**Marin Municipal Water District  
Addendum to the Amendment of the Mt.  
Tamalpais Watershed Road and Trail  
Management Plan – Restoration of Azalea Hill  
Initial Study/Mitigated Negative Declaration**

**State Clearinghouse No. 2004082018**

**March 2025**

Figure 1 Azalea Hill Restoration Project Location

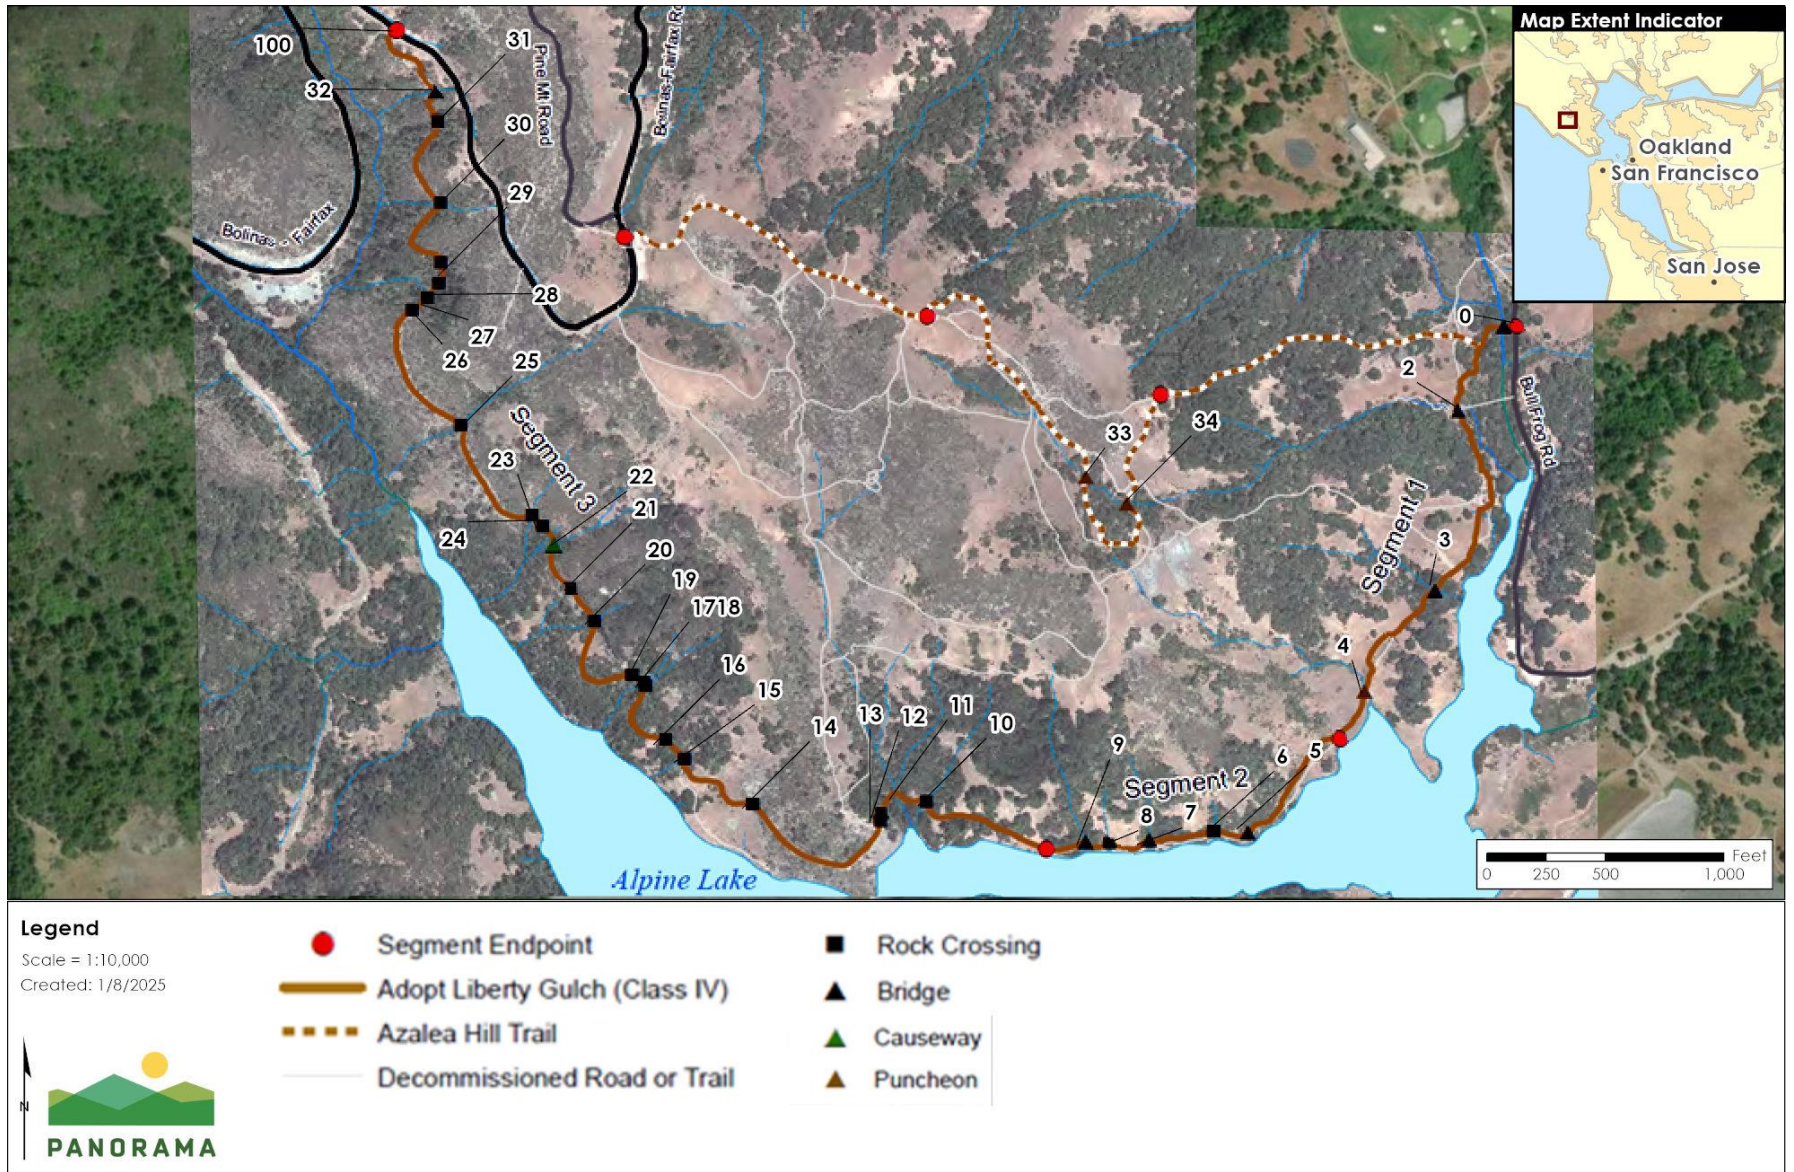
The Project is currently being implemented; however, an approximately 288-foot section of Liberty Gulch Road (within Segment 2, as shown in Figure 1) planned to be improved to a Class IV road through widening from approximately 18 to 24 inches to 4 feet is flanked by extensive populations of rare plants. While the approved Project allows for widening the trail and mitigating the effects to these rare plant populations, the District staff have found that the least impactful method in this area is to leave the trail at its current width and not actively disturb the rare plant populations. Additionally, improvements to Liberty Gulch Road under the Project included stream crossing upgrades at 34 sites. Six of these sites no longer need upgrades or upgrades can be minimized while still protecting water quality and reducing erosion from the road and trail improvements.

A 288-foot section of the Liberty Gulch Road segment, from stream crossing site 7 to 9 (shown in Figure 1), is surrounded by numerous rare plants, including extensive Mt. Tamalpais lessengia and Tiburon buckwheat. This section of trail is narrow (from 18 to 24 inches in width), and sloped, with little room to expand the trail and with rare plants flanking the existing trail. The Azalea Hill Restoration project's IS/MND includes Mitigation Measure 3.2-B.2 that requires avoidance of rare plants, and if avoidance is not practicable, development of a rare plant mitigation and monitoring plan. Per the measure, "The rare plant mitigation and monitoring plan shall maintain pre-project rare plant populations by replacing all affected rare plants via seeding or transplanting (relocating). The success criteria for seeded and relocated plants shall be full replacement at a 1:1 ratio [number of plants established = number of plants impacted] after five years, accounting for annual variability as measured by reference populations near the project area or in similar environmental (soil, aspect, elevation, etc.) conditions."

Page 2.23, Figure 2.05 – Oat Hill Map

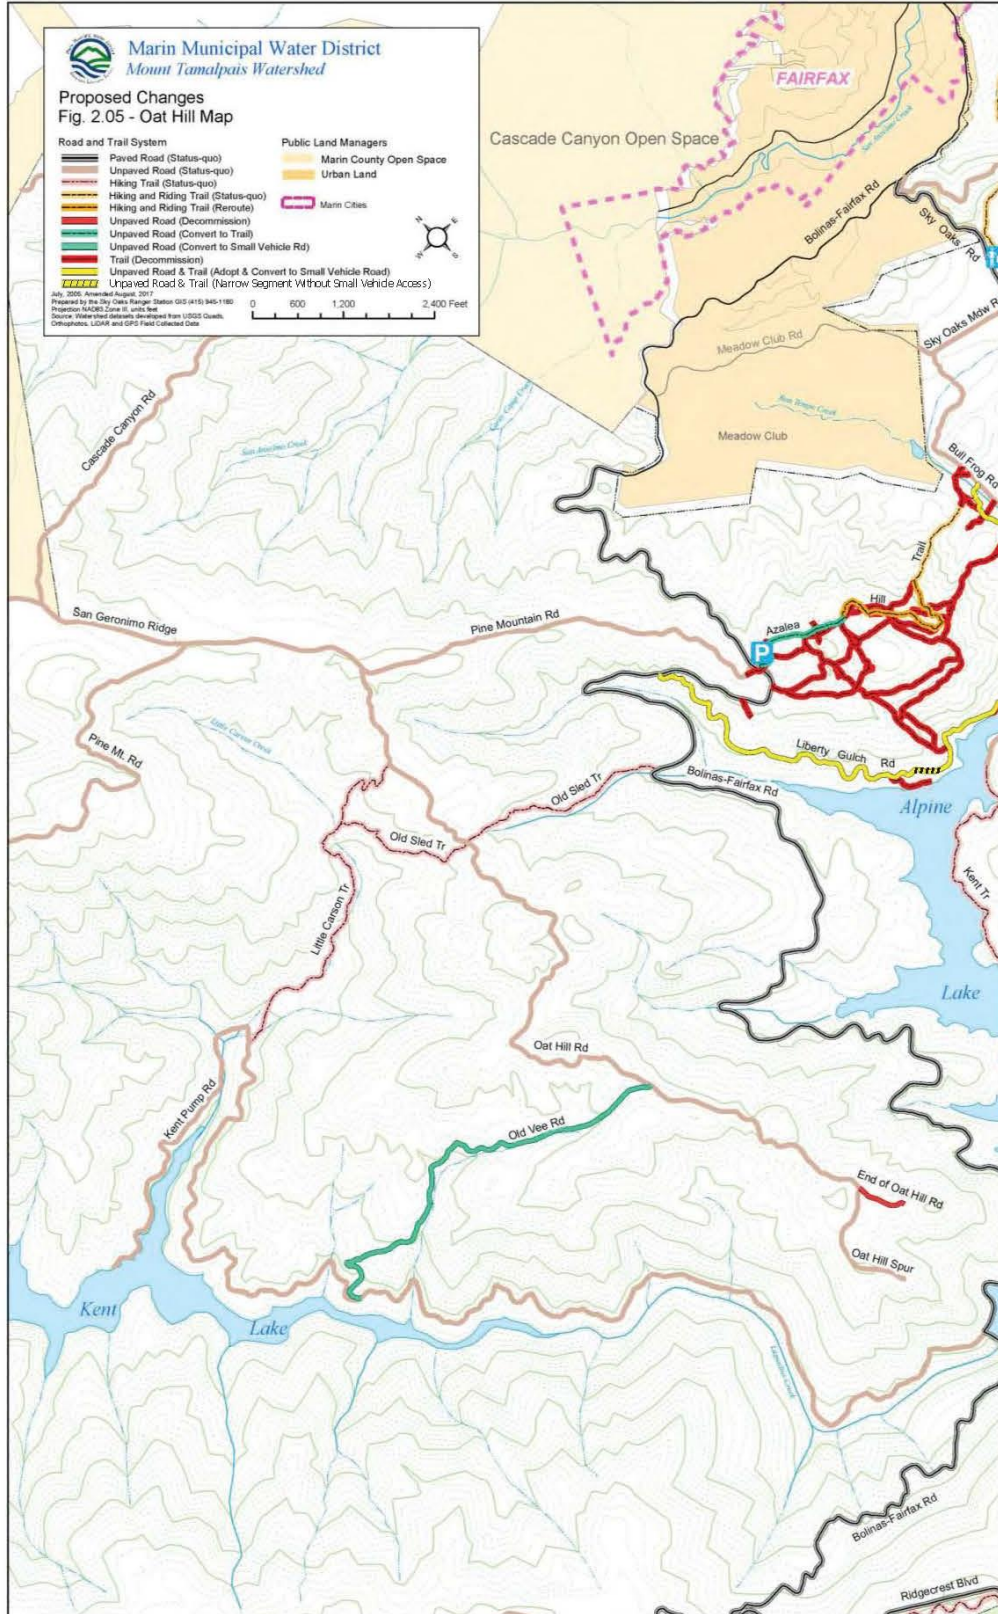
The Azalea Hill Restoration project included amendments to Chapter 2 of the 2005 RTMP. Minor changes to the amendments are proposed under the revised Project. This section identifies the chapter and paragraph of the proposed additional changes. The associated additions are shown in underline text.

“Noteworthy changes include the removal of redundant or unused roads in the vicinity of Peters Dam. Some other roads will be converted to Class IV, or small vehicle roads, to minimize erosion while still providing route connectivity. These include Grassy Slope Rd., Old Vee Rd., Lower Rocky Ridge, the southern portion of Concrete Pipe Rd., Lower Eldridge Grade, and Liberty Gulch Rd. A few roads will be converted to trails. Azalea Hill Rd. will be converted to a trail, mainly to keep cyclists from continuing beyond the road and down onto the trail, or worse, creating new trails that damage the environment and stress limited enforcement resources. A noteworthy area of decommissioning is in the Upper Berry-Lagoon Road area, primarily because of environmentally sensitive habitat concerns (serpentine soils), erosion and route redundancy that results in considerable search and rescue efforts. Most of the adoptions are on the periphery of the watershed and serve as established connectors to the near-by cities and towns. The decommissioning of Bald Hill Road and the end of Worn Springs Road, totaling approximately 0.15 miles, will be replaced with a new trail rerouted to a more stable location. Only one non-system road was adopted, Liberty Gulch Road, to improve connectivity for all users between the lakes area and the Pine Mountain area. A 288-foot section of Liberty Gulch Road is 24 to 18 inches wide and will not be open to patrol ATVs or trucks. Liberty Gulch Road, including this 288-foot segment, maintains multi-use for hikers, bicyclists, and equestrians, with modifications to protect sensitive resources and to ensure safety.”

\*288Liberty Gulch Road is classified as Class IV, including the narrower 288-foot segment of road, allowing for multiple recreational uses (i.e., bicycling, hiking, and equestrian), but with modifications to the use through the narrowed road width along this segment. No patrol trucks or ATVs are allowed on this 288-foot section of road.

**Figure 3**      **Locations of Stream Crossing Improvement Changes for the Revised Project**

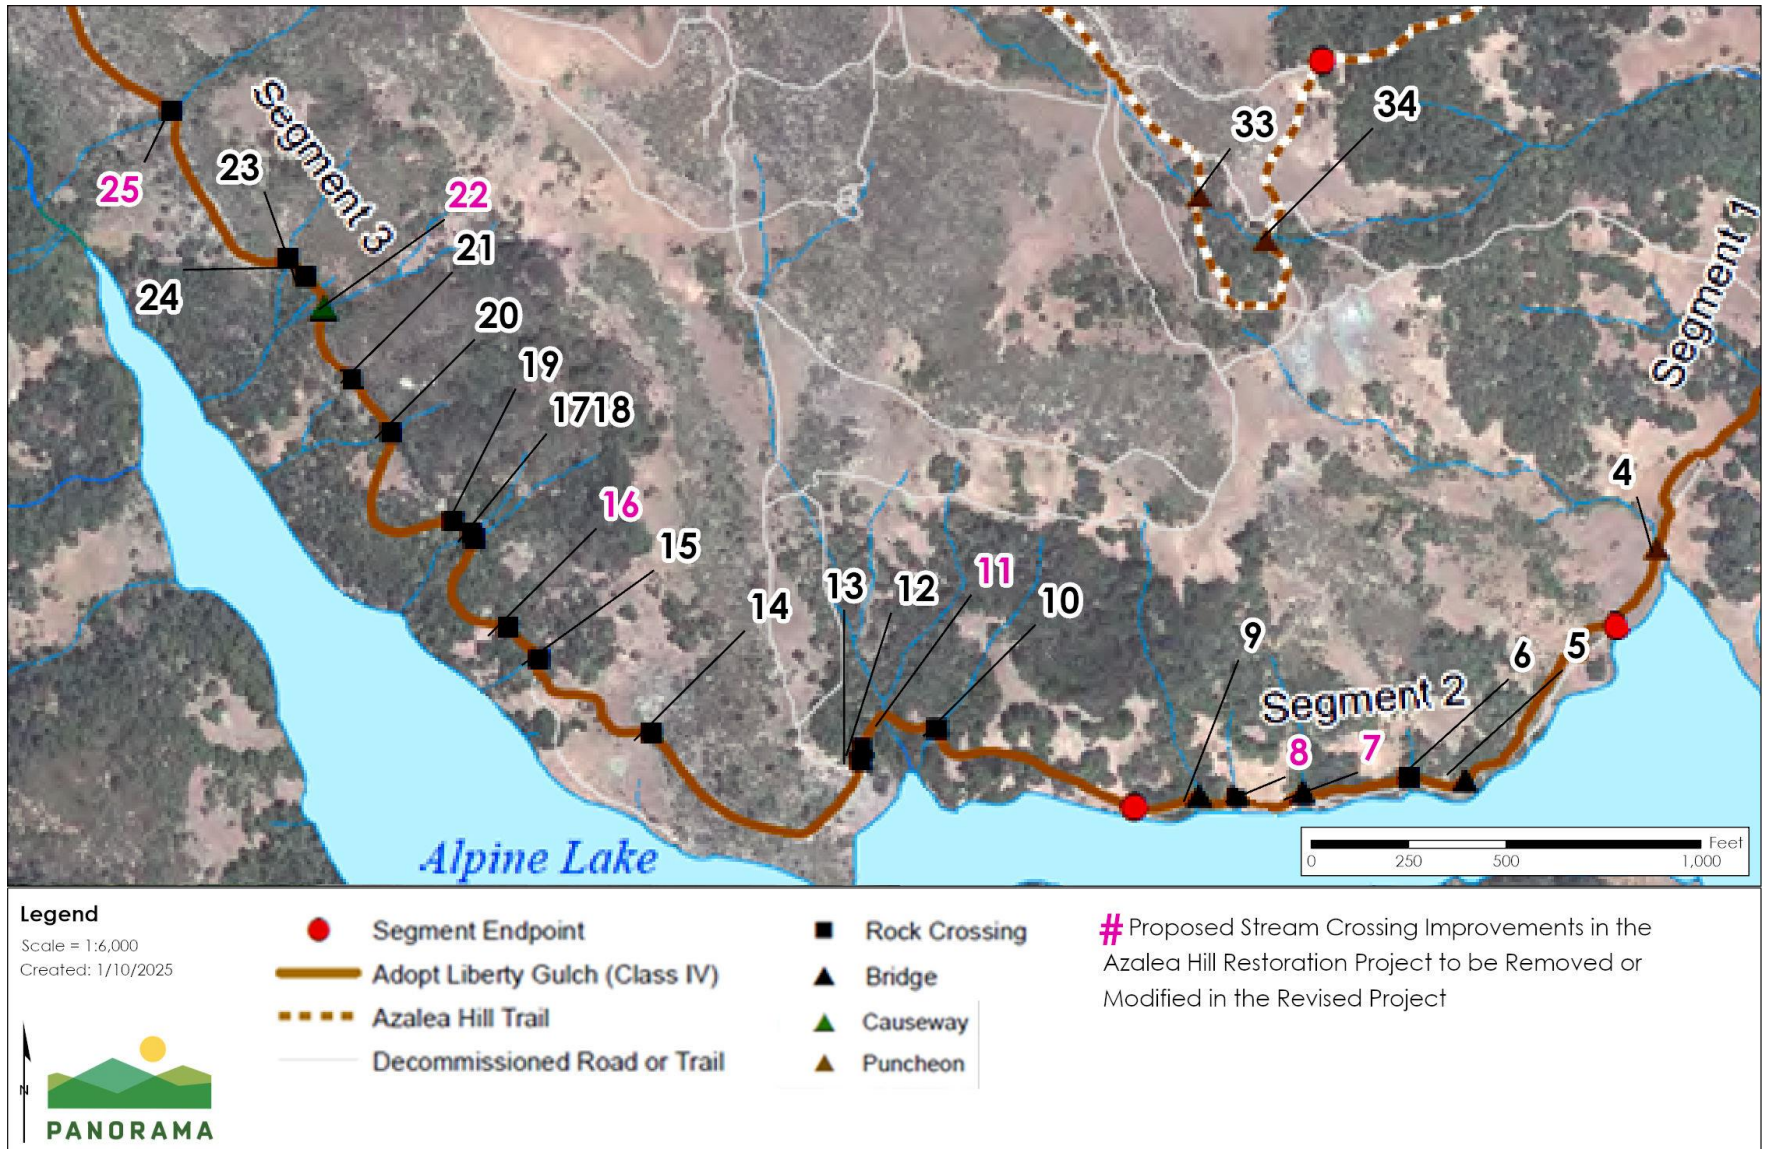
The Azalea Hill Restoration project included 34 stream crossing improvements. Six of these crossing improvements were determined not needed or need less work after field evaluation, which is in line with the District's stated approach in the Project of being "light on the land" in order to minimize effects to other sensitive resources, including rare plants. The crossings that are removed or modified as part of the revised Project are summarized below and shown in

Figure 3. Each of the modifications or removals were assessed by the District to ensure that the changes would still provide adequate erosion and sedimentation control.

Site	Crossing Type	Initially Proposed Action	Reason for Removal or Modification of Action
7	Bridge	Construct a 20-foot bridge above creek	No bridge construction due to presence of rare plants but some armoring to be installed avoiding the plants and to provide adequate water quality protection. This crossing is within the section of Liberty Gulch Road to be left at current conditions and width.
8	Armor	Construct an armored wet crossing with 6 to 12-inch rock	To retain existing hydrologic function as well as water quality, while avoiding impacts to rare plants precisely hand-place two to three 12" rocks into the stream crossing.
11	Culvert	Slip-line culvert and add trash rack	The culvert is functioning and clean, therefore, no work is needed.
16	Armor	Construct armored wet crossing (5 cubic yards of 1-foot to 2-foot rock), treat approach, pull culvert	The culvert is functioning and clean, therefore, no work is needed.

22	Causeway	Raised boardwalk setback from fill slope edge (50 feet long x 4 feet wide).	No associated road widening is needed in this section of road; therefore, the causeway is not needed to keep users out of the stream. Rolling dips and drainage outlets would be added to adequately protect water quality.
25	Armor	Armored crossing, 50 cubic yards rock over 450 square feet (1-foot to 2-foot ft rock). Pull unstable fill, remove culvert. Treat 400 feet of approach	Leave culvert in place and armor instead of pulling culvert to avoid impacts to rare plants, while maintaining hydrology.
